WALK-THRU BUILDING PERMIT

FILE INQUIRY FORM

Property Address: 2600 Wellworth Way.

*THIS IS A REQUEST TO AMEND BUILDING PERMIT # B00158084
FOR THE ADDITION OF A ~~PERCH~~ ^{SUNROOM} FROM 12' X 34' TO 14' X 34'.*

REVISION
R00158084

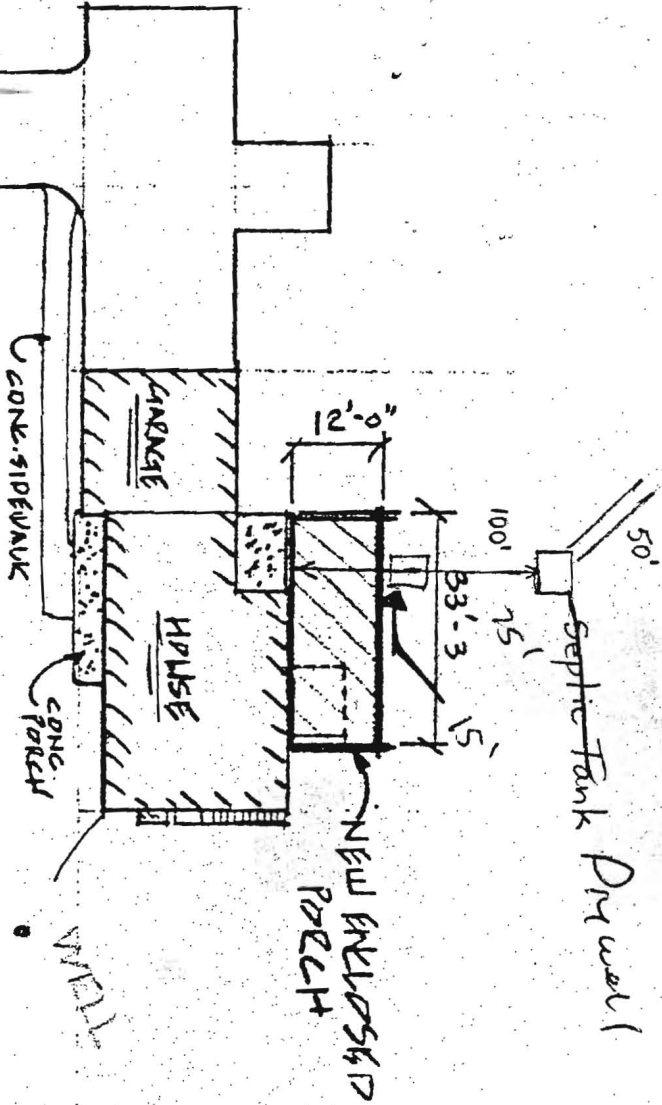
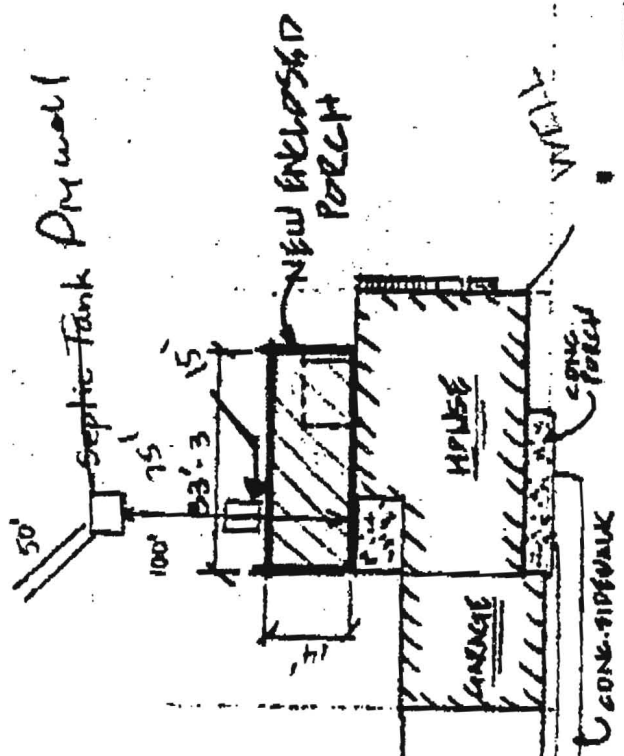
*SINCE I HAD TO RELOCATE THE SEPTIC TANK PER HEALTH
DEPARTMENT REQUIREMENT, THE SPACE ARRANGEMENT FOR
THE PORCH WILL NOW ACCOMODATE A 14 FOOT WIDTH*

Change size of Sunroom to 34x14.

*3/26/06 New deck size OK
(E)*

| TITLE GRADING STUDY | | | |

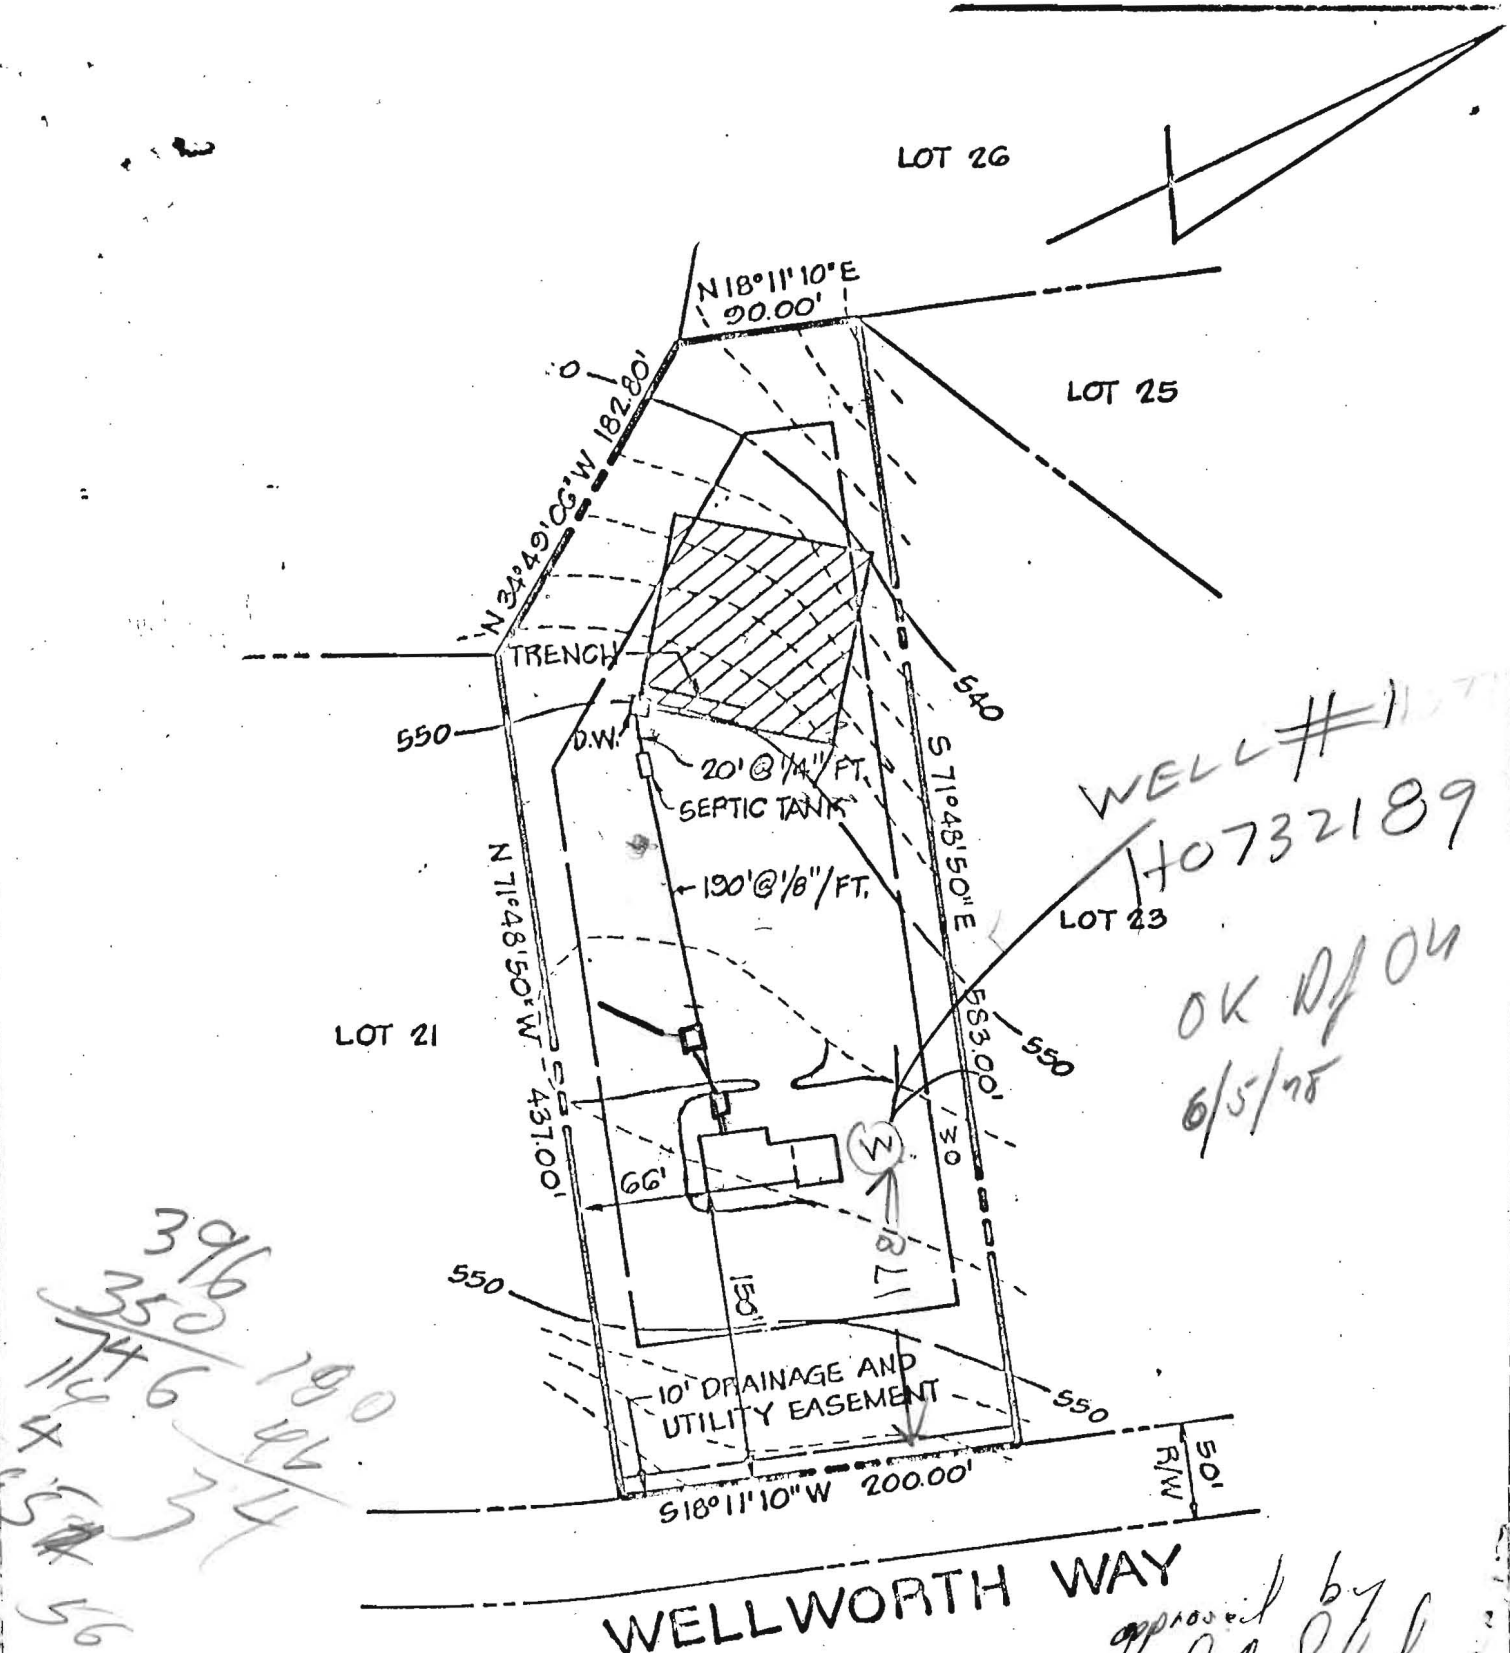
8/8/05 - Home owner wants to appeal our decision, to ~~my~~ upgrade septic + trenches for building permit for a porch.

- After discussion with Bob Weber (Director) we will allow just the tank relocation out of the 100' well radius.

However, if contractor cannot fit tank out of well radius + between drywell the upgrade must occur.

Septic installed in 1978, it is very close to failing.

Layout for tanks is very important to check to see if it is 100' from the well.

if tank can go in (out of radius) + hooked up to dry well, we shall refund the upgrade fee to just tank replacement fee. 165 versus ^A396.

Refund may be available if only tank is replaced.
